ADDENDUM NUMBER ONE (001)

PROJECT: RE-BID **Temporary Milk and Blood Lab**

Marquardt Building Augusta, Maine

PROJECT NUMBER: Ames Associates Project No. 2015114

PANEL SCHEDULES

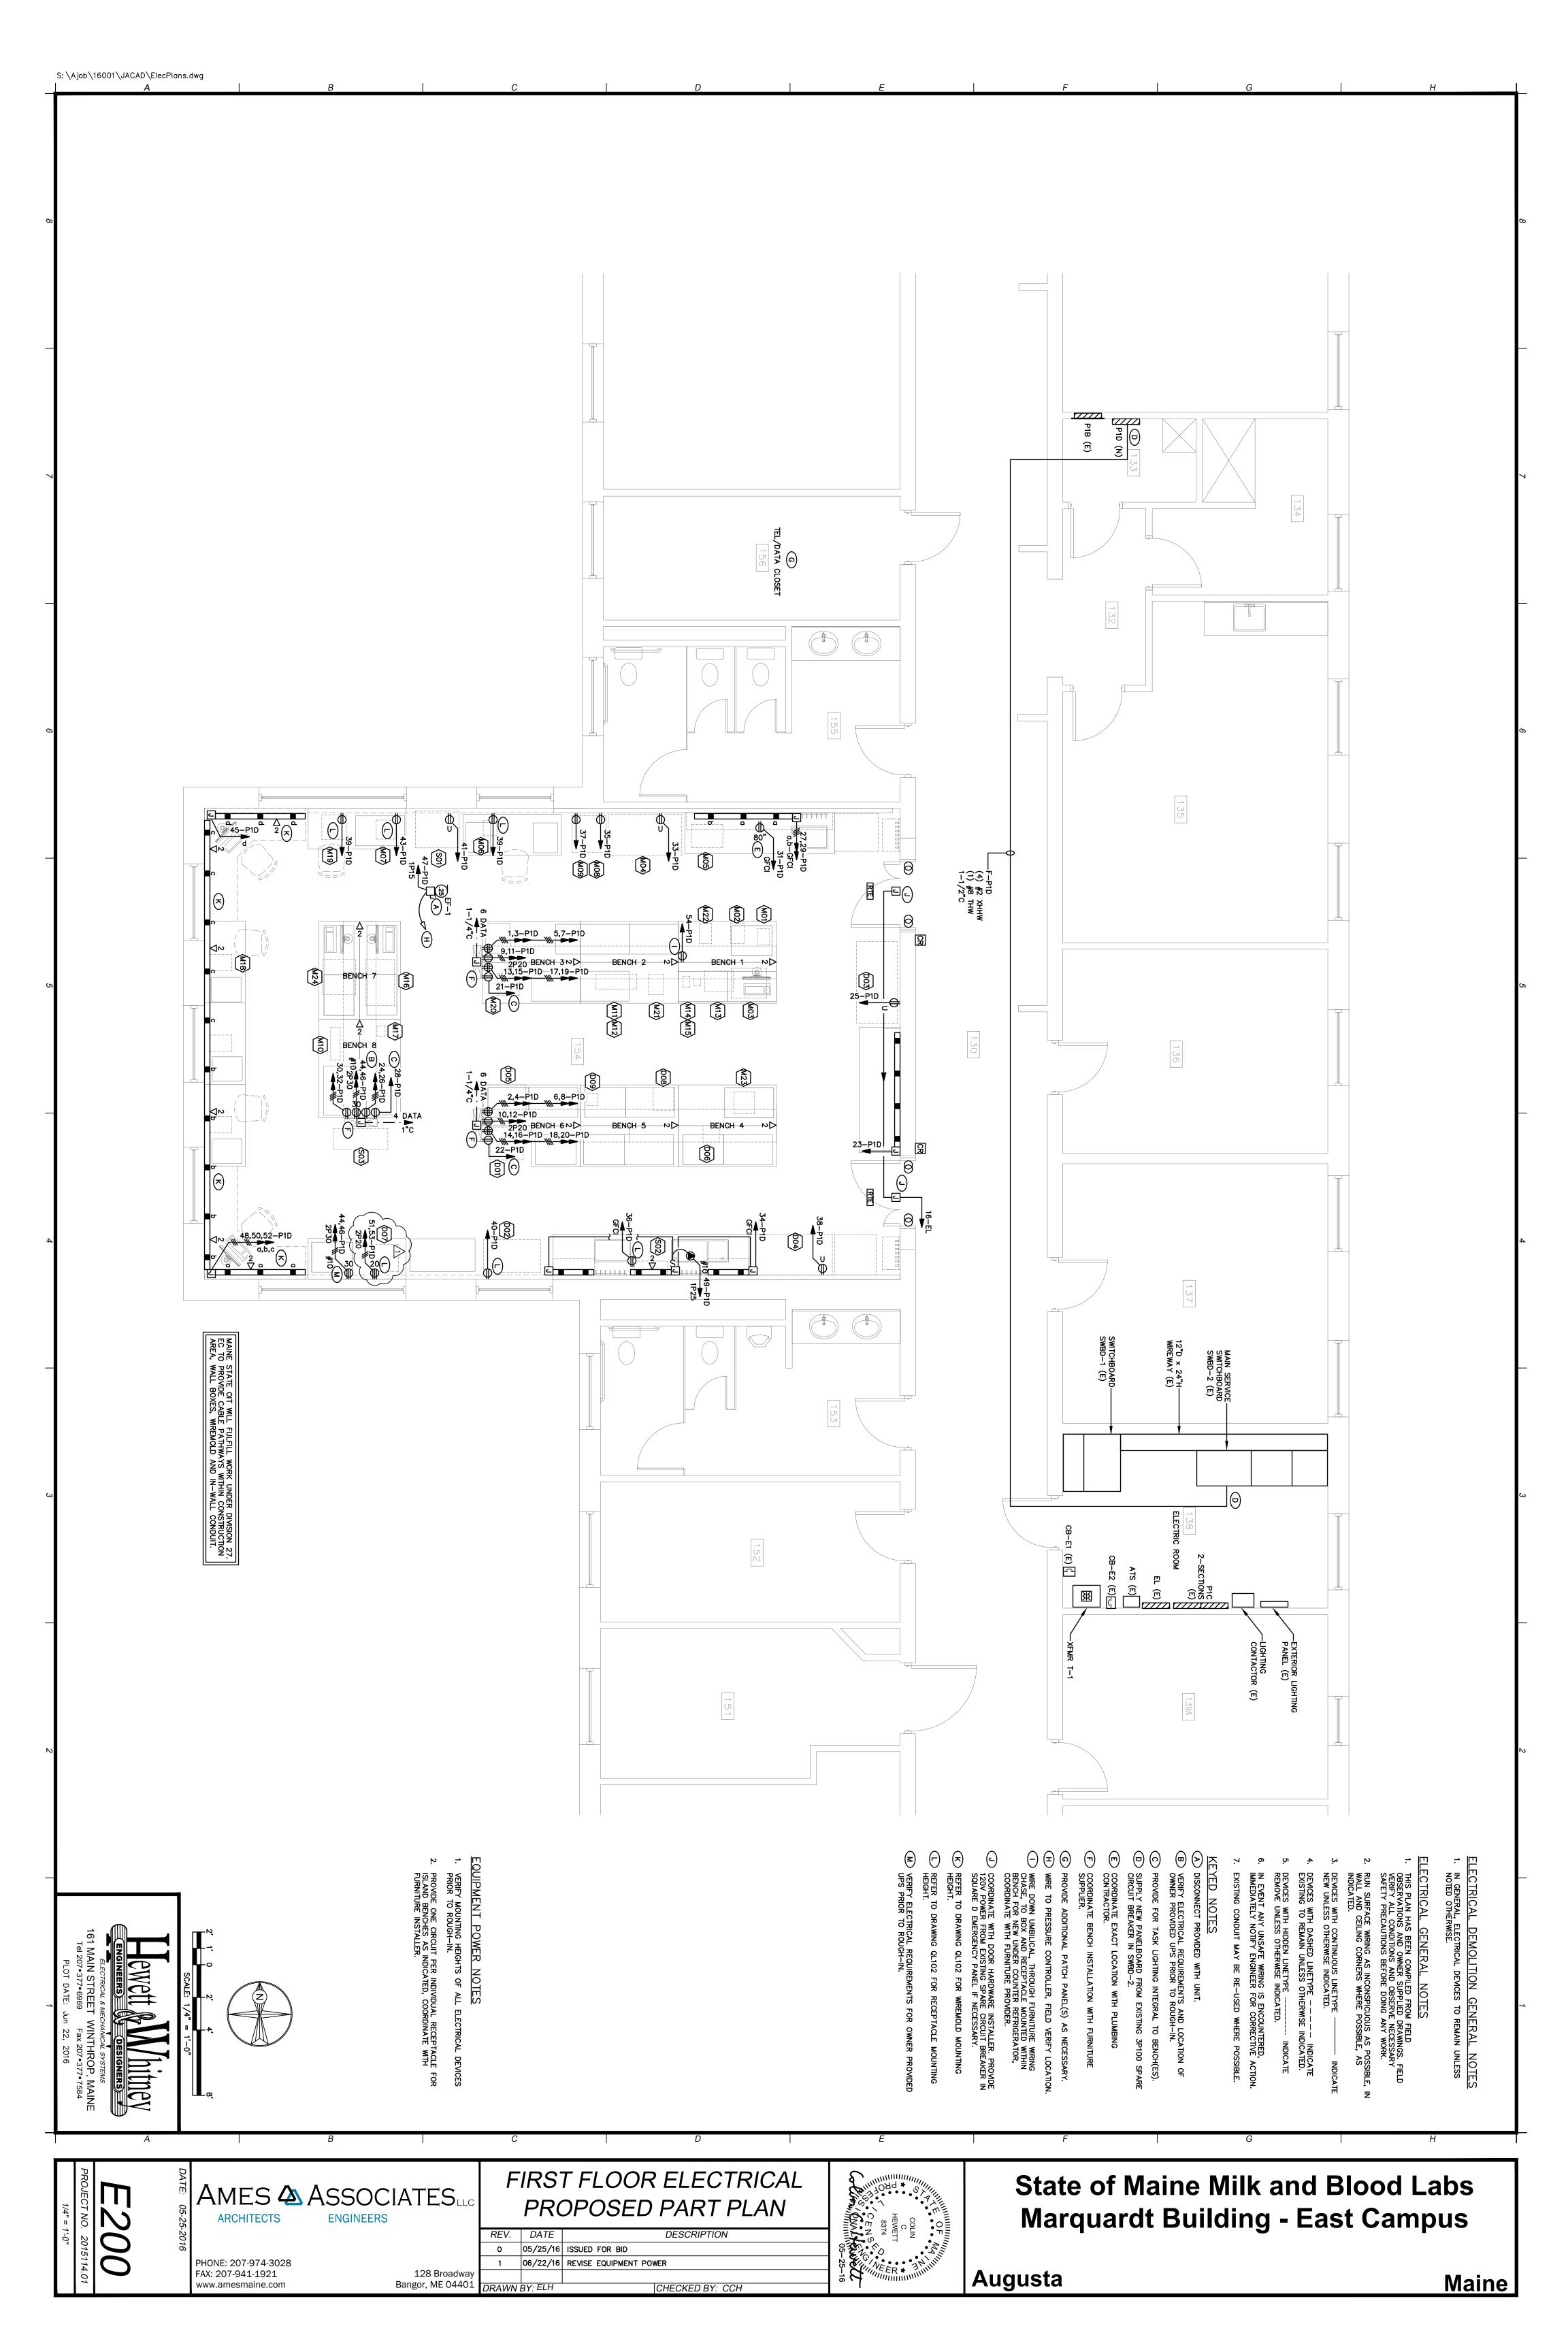
2.9 I noticed that the changes in E200 and E300 were not incorporated into these drawings.

ANSWER: The information from the earlier bid process should have been incorporated into the documents. Sheets E200 and E300 are included as part of this Addendum
